August 10, 2018

ND-18-1037
10 CFR 50.90
10 CFR 52.63

Southern Nuclear Operating Company
Vogtle Electric Generating Plant Units 3 and 4
Request for License Amendment and Exemption:
Power Operated Relief Valve (PORV) Noise Mitigation (LAR-18-021)

Figure 2.2.4-1 (Sheet 1 of 3)
Steam Generator System

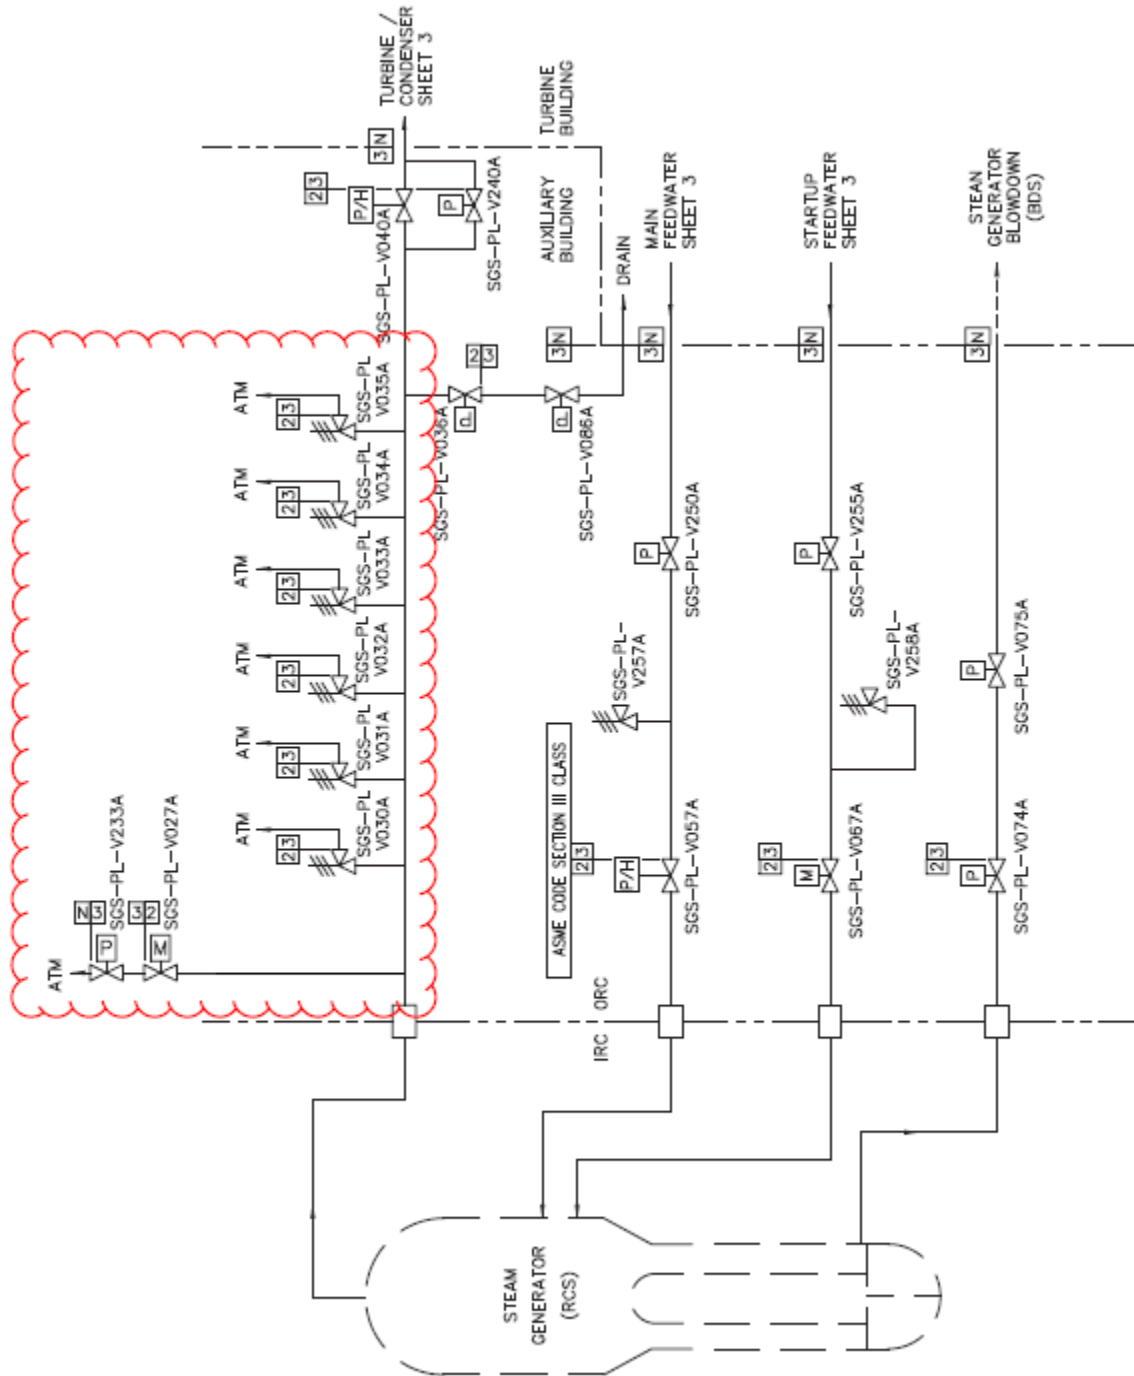
Revise COL Appendix C (and corresponding plant-specific Tier 1) Figure 2.2.4-1, sheet 1 to relocate the branch line to the PORV as shown below:

Figure 2.2.4-1 (Sheet 2 of 3)
Steam Generator System

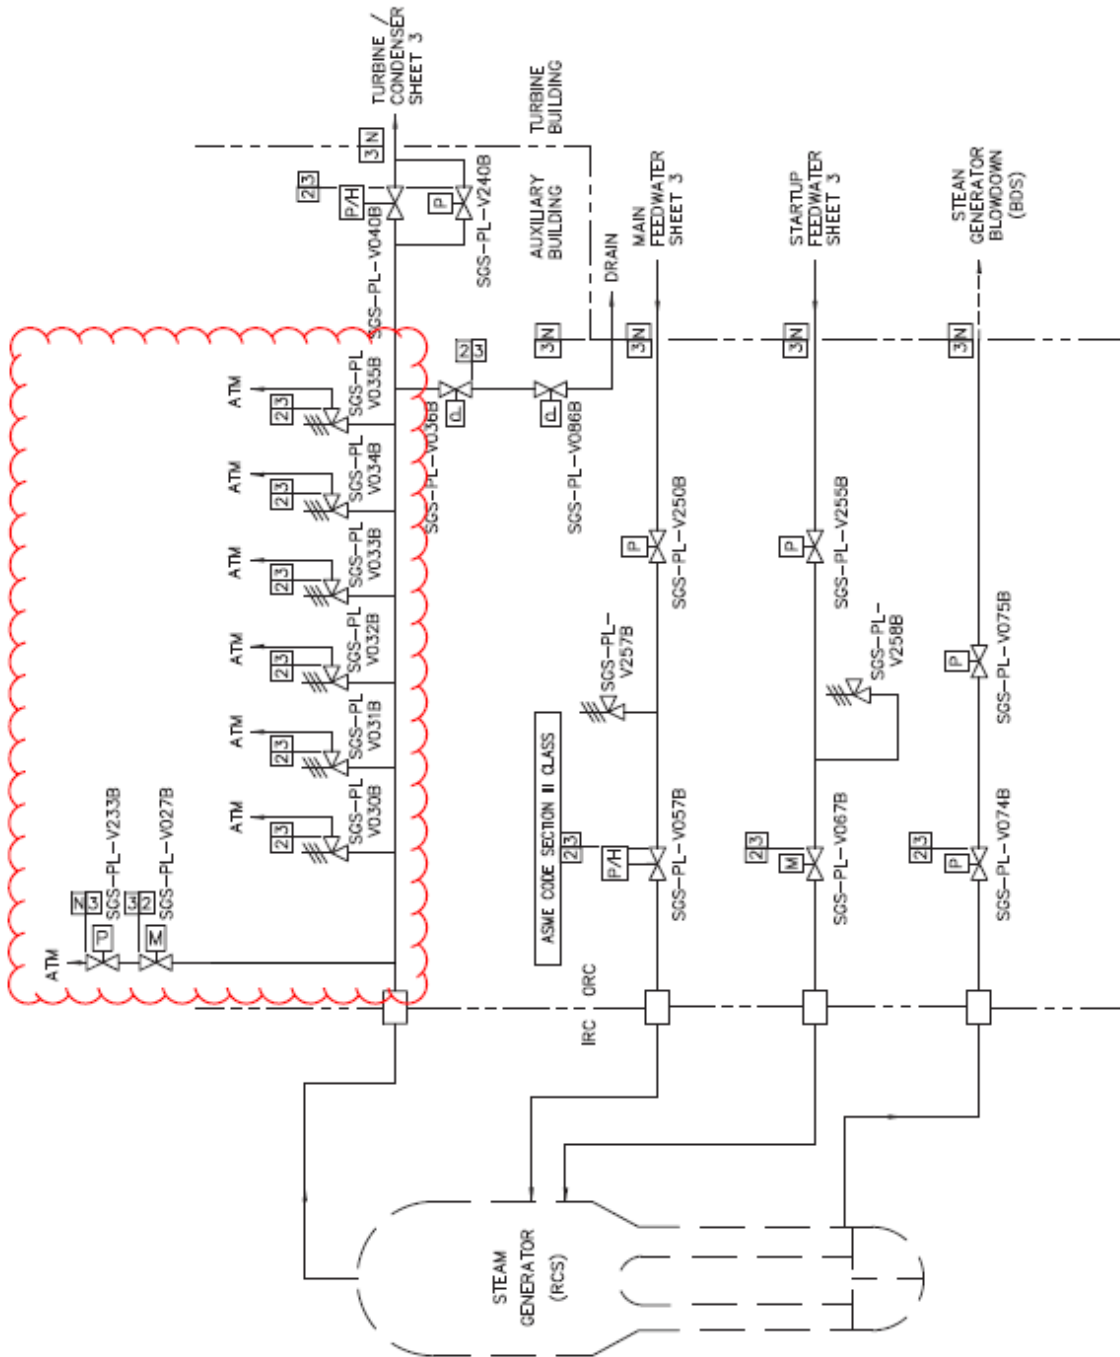
Revise COL Appendix C (and corresponding plant-specific Tier 1) Figure 2.2.4-1, sheet 2 to relocate the branch line to the PORV as shown below:

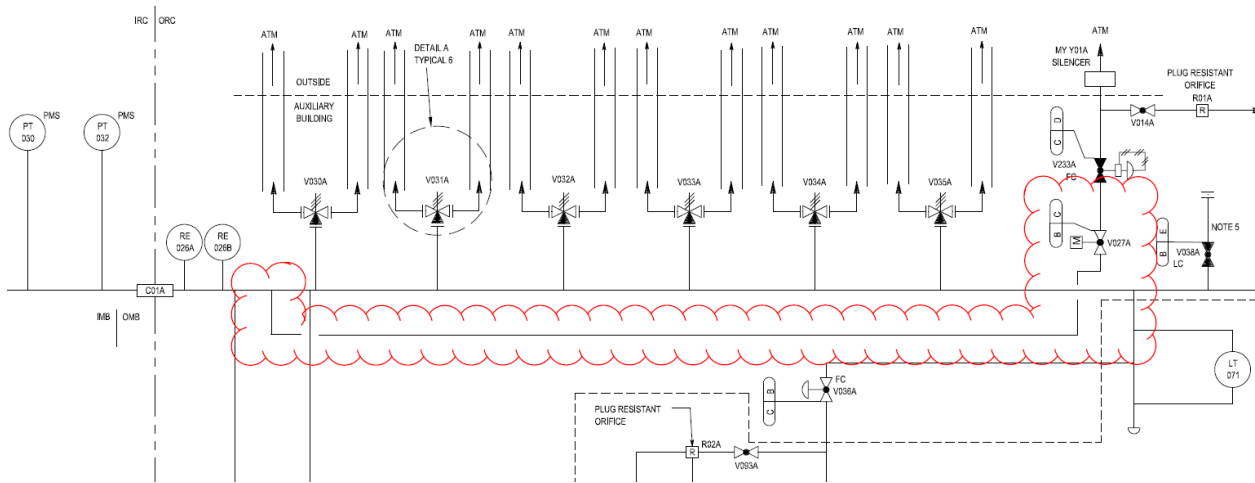
Revise UFSAR Figure 10.3.2-1 (Sheet 1), to change relocate the branch line to the PORV and PORV block valve and to change the PORV block valve from a gate valve to globe valve, as shown below:

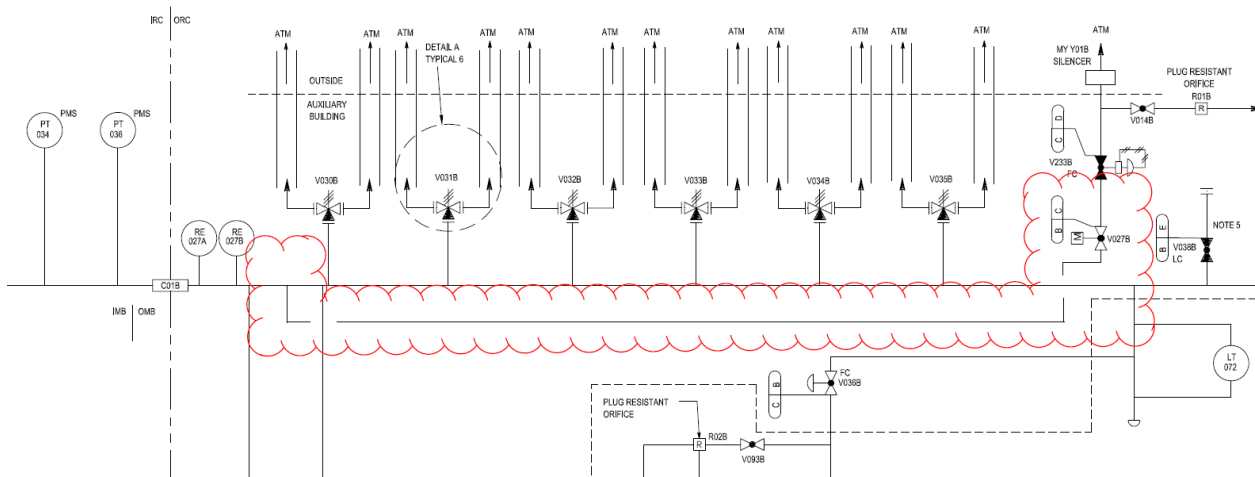
Revise UFSAR Figure 10.3.2-1 (Sheet 2), to change relocate the branch line to the PORV and PORV block valve and to change the PORV block valve from a gate valve to globe valve, as shown below:
